APPLICATION NO.	FILING DATE	FIRST NAMED INVENTOR	ATTORNEY DOCKET NO.	CONFIRMATION NO.
10/567,170	02/03/2006	Akimitsu Tsuda	1176/313	9622
46852	7590	12/11/2007	EXAMINER	
LIU & LIU 444 S. FLOWER STREET, SUITE 1750 LOS ANGELES, CA 90071			CARIASO, ALAN B	
			ART UNIT	PAPER NUMBER
			2885	
			MAIL DATE	DELIVERY MODE
			12/11/2007	PAPER

Office Action Summary

DETAILED ACTION

Fig. 4

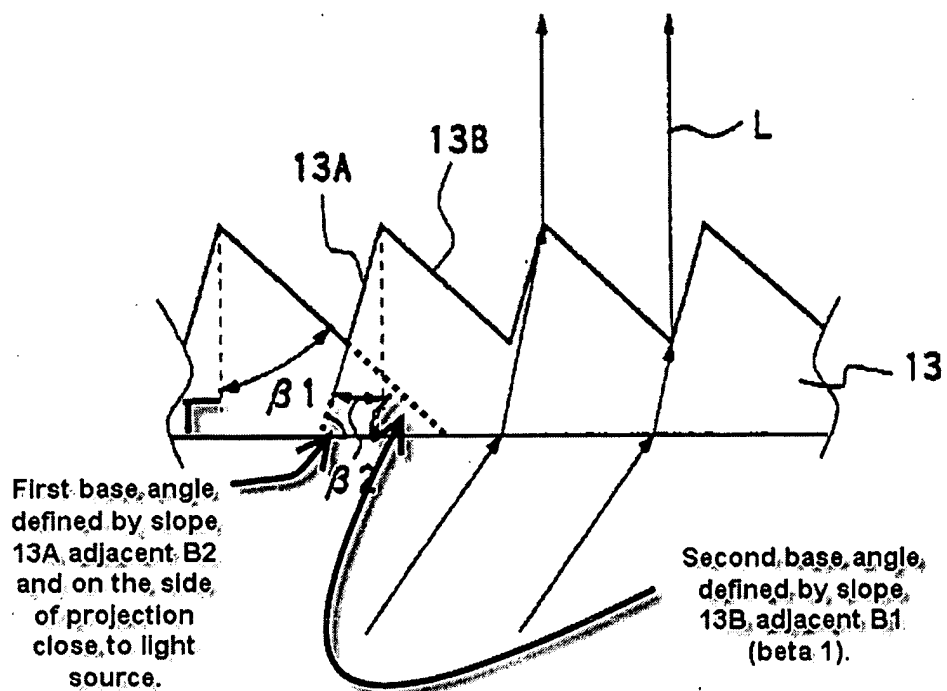
viewing angle improvement means (13) is asymmetric prism sheet (col.6, lines 40-41) having a plurality of projections (13A, 13B, fig.4 depicted below with added info.); wherein said projections of said asymmetric prism sheet (13) have a first base angle α of 75° to 90° and a second base angle \sim of 45° to 60° . First base angle, shown below, and with the adjacent inclination angle β_2 (of slope 13A), both form the acute angles of the smaller-area dotted right triangle. Similarly, the second base angle, shown below, and with the adjacent inclination angle β_1 (of slope 13B), both form the acute angles of the larger-area dotted right triangle. OHKAWA discloses the inclination angles β_2 and β_1 defining slopes 13A and 13B, respectively, with respect to the normal erected on the general surface of the guide plate, as illustrated by the right angle dotted lines below.

OHKAWA discloses that inclination angle $\beta_2 = 5.6$ degrees (col.6, line 52; col.9, line 29), which by simple geometry/trigonometry means the same as the first base angle being 90 minus 5.6, or 84.4 degrees. With the other inclination angle $\beta_1 = 35$ degrees (col.6, line 52; col.9, line 29), it means that the second base angle is 90 minus 35, or 55 degrees.
